Technical Service Bulletin

SUBJECT:		No: TSB-20-23C-001	
CHECK ENGINE LIGHT ILLUMINATES (P1740)		DATE: October 2020	
		MODEL: See Below	
CIRCULATE TO:	<input type="checkbox"/> GENERAL MANAGER	<input checked="" type="checkbox"/> PARTS MANAGER	<input checked="" type="checkbox"/> TECHNICIAN
<input checked="" type="checkbox"/> SERVICE ADVISOR	<input checked="" type="checkbox"/> SERVICE MANAGER	<input checked="" type="checkbox"/> WARRANTY PROCESSOR	<input type="checkbox"/> SALES MANAGER

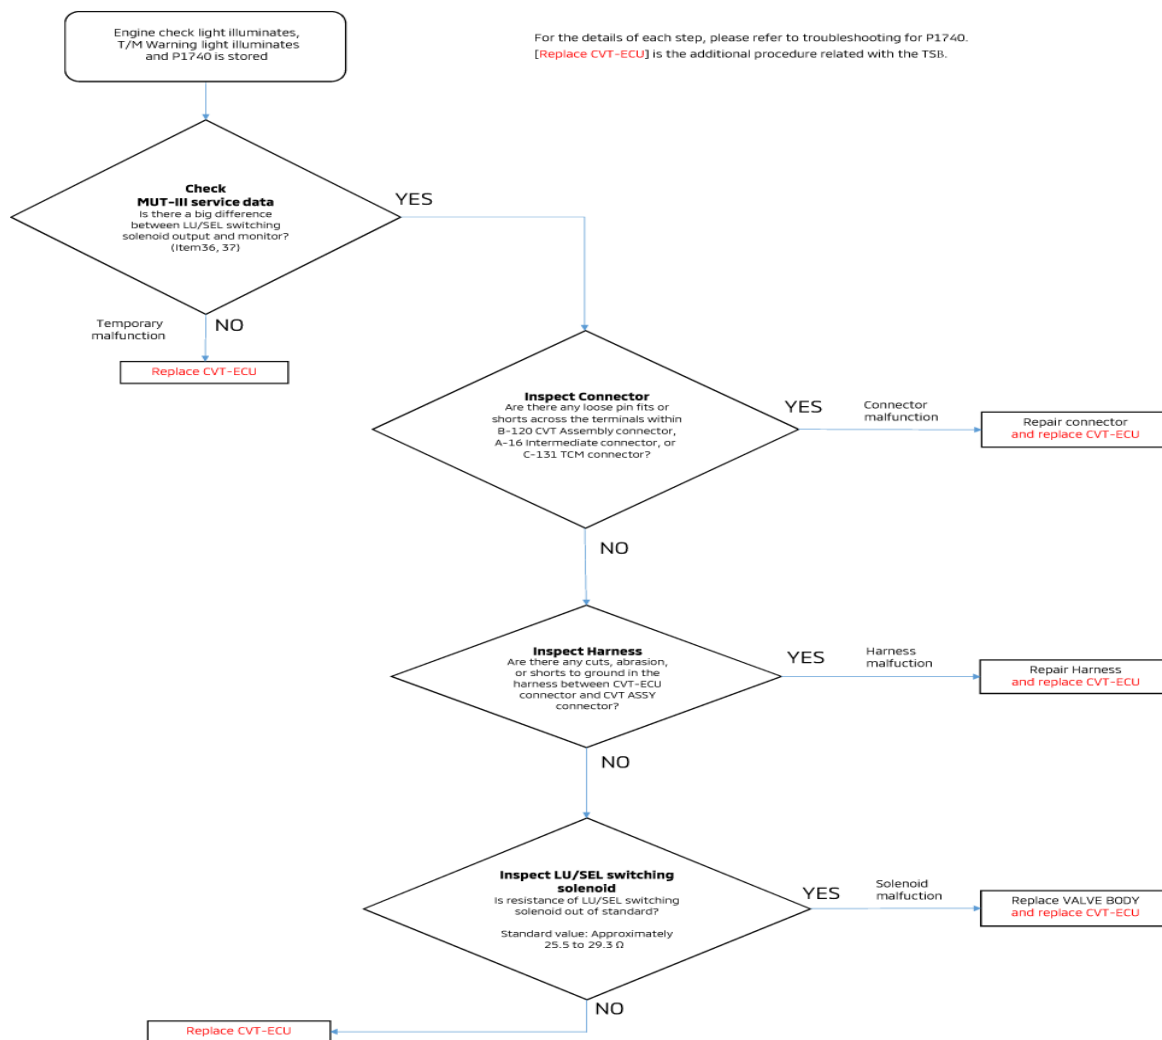
After confirming warning light illumination and DTC: P1740 stored, follow the trouble shooting procedure for P1740 and replace the CVT-ECU with a counter-measure part. The counter-measure part changes the setting of the solenoid valve voltage monitoring circuit in the CVT-ECU.

Follow the work procedure illustration below for replacement of the CVT-ECU and refer to the applicable Service Manual for CVT-ECU re-learning procedure.

This TSB instructs dealers to replace the CVT-ECU with a counter-measure part to change the setting of the solenoid valve voltage monitoring circuit.
